**MONTGOMERY COUNTY PLANNING DEPARTMENT**  
 THE MARYLAND-NATIONAL CAPITAL PARK AND PLANNING COMMISSION

**MEMORANDUM**

**REVIEW TYPE:** Site Plan Review  
**CASE #:** 820070190  
**PROJECT NAME:** Leisure World, Villa Cortese, Building V  
**APPLYING FOR:** Approval of 46 dwelling units including 6 Moderately Priced Dwelling Units (MPDUs)  
**REVIEW BASIS:** Div. 59-D-3 of Montgomery County Zoning Ordinance  
**ZONE:** PRC  
**LOCATION:** On Georgia Avenue, 107 feet SE of Rossmoor Boulevard  
**MASTER PLAN:** Aspen Hill Master Plan  
**APPLICANT:** Rossmoor – IDI Villa Cortese, LP  
**FILING DATE:** April 4, 2007  
**HEARING DATE:** December 13, 2007

Diagrammatic representation of the recommended linkage between the pedestrian systems of Building V and Mutual 6-B.

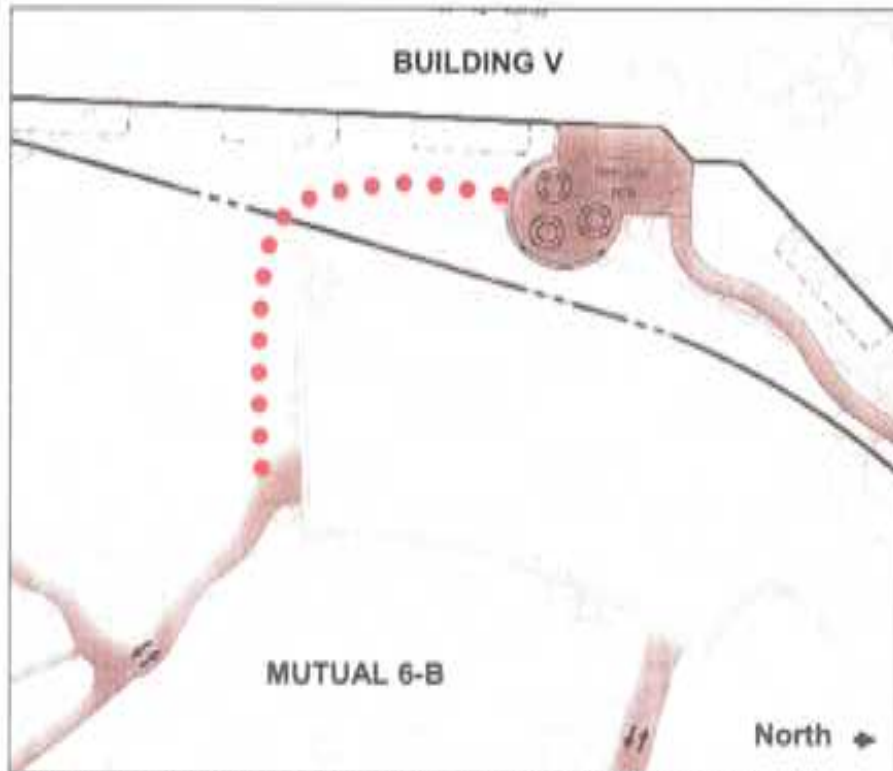
The proposed pedestrian system associated with Building V does not connect to the existing path system at Mutual 6-B, located to the rear of the proposed building. The Applicant agreed to provide the path connection, however the residents of Mutual 6-B consistently opposed having any linkages or improvements on their property associated with Building V (Attachment C). As a result, the linkage between the two pedestrian systems could not be accomplished.

In a letter dated August 7, 2007 (Attachment D), Staff requested that the pedestrian path at the rear of Building V be extended and connected to the pedestrian system at Mutual 6-B. According to the Montgomery County Recreation Guidelines, a pedestrian path is “a coherent and continuous network of sidewalks and paths that provides safe pedestrian linkages to major destinations and recreational opportunities for the community.” As proposed, future residents of Building V will have to walk through a parking lot in order to access the pedestrian network at Mutual 6-B, which compromises their safety as well as access to adjacent amenities.

## **II. Visitor’s parking lot at the rear of Building V**

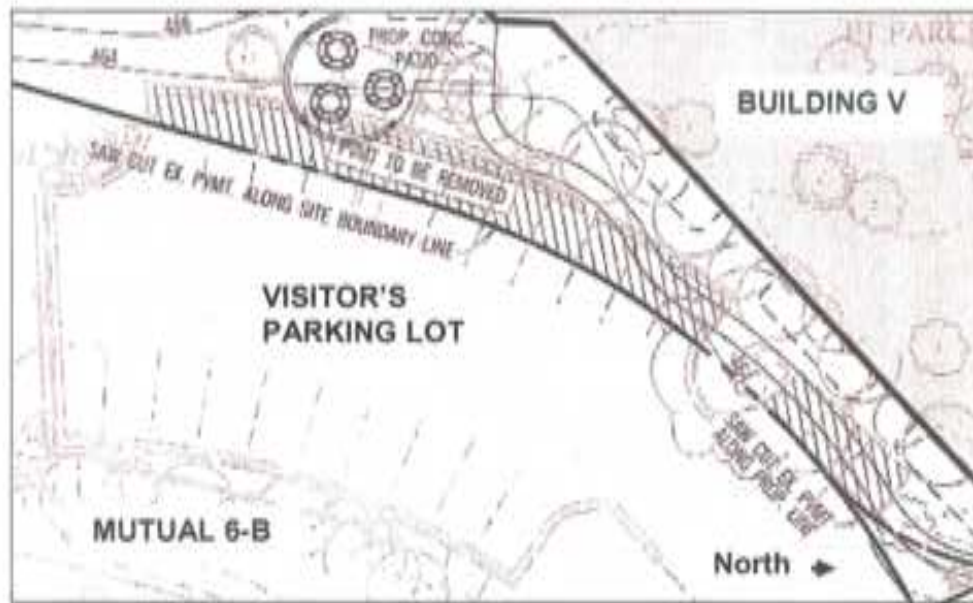
The site plan proposes to eliminate a portion of the existing visitor’s parking lot that is within the property boundary. The resulting parking lot will have a bay of usable spaces closest to Mutual 6-B and a bay of unusable spaces closest to Building V. Excess and unused pavement, per the standards of parking lot design (Section 59-E), could be removed in favor of additional landscaped areas and buffering from the proposed terrace units in Building V.

The visitor’s parking lot is partly located on Mutual 6-B and partly on the site for Building V. This site plan proposes to eliminate all pavement within the property boundary for Building V in order to have a minimum setback from the building and to build the sidewalk leading to the concrete patio. The resulting parking lot will have a net total of 10 spaces after having eliminated 14 spaces. These spaces accommodate guest and overflow parking from Mutual 6B.

Pavement to be removed is shown with diagonal hatch pattern.

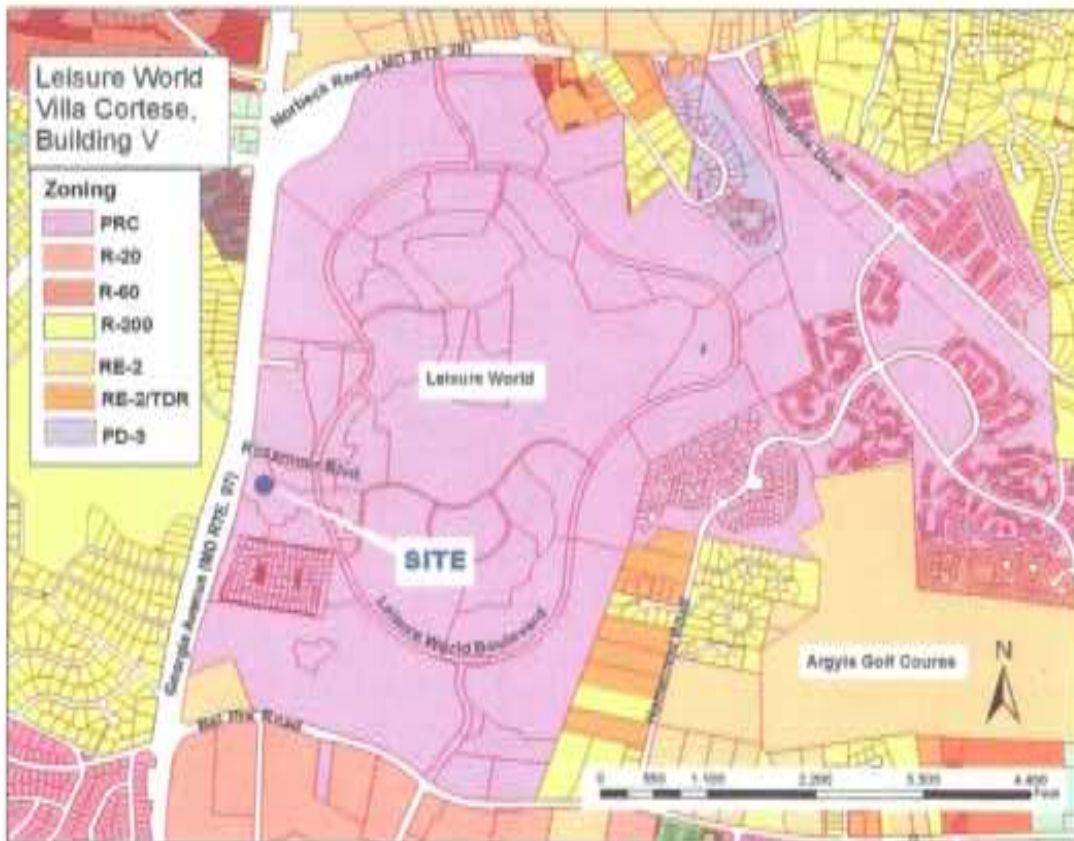
Excess and unused pavement, per the standards of parking lot design (Section 59-E), should be removed in favor of additional landscaped areas and buffering from the proposed terrace units in Building V. The patios of the terrace units in Building V have a minimum setback of 11 feet from the edge of pavement. To improve privacy and compatibility, Staff has requested that the patios be screened with low-growing evergreen shrubs.

Additionally, by decreasing the amount of impervious surfaces, greater environmental benefits are accomplished, such as lower run-off and decreased reflective heat. Lastly, a revised layout will contribute to orderly and safe vehicular circulation, and parking.

The loss of 14 parking spaces was considered acceptable since this parking lot served mainly visitors to the sales office, which is being demolished as part of this site plan. The parking requirements for residents of Building V are fully met onsite. In addition, all units at Mutual 6-B have designated parking spaces in driveways or in the existing parking garages.
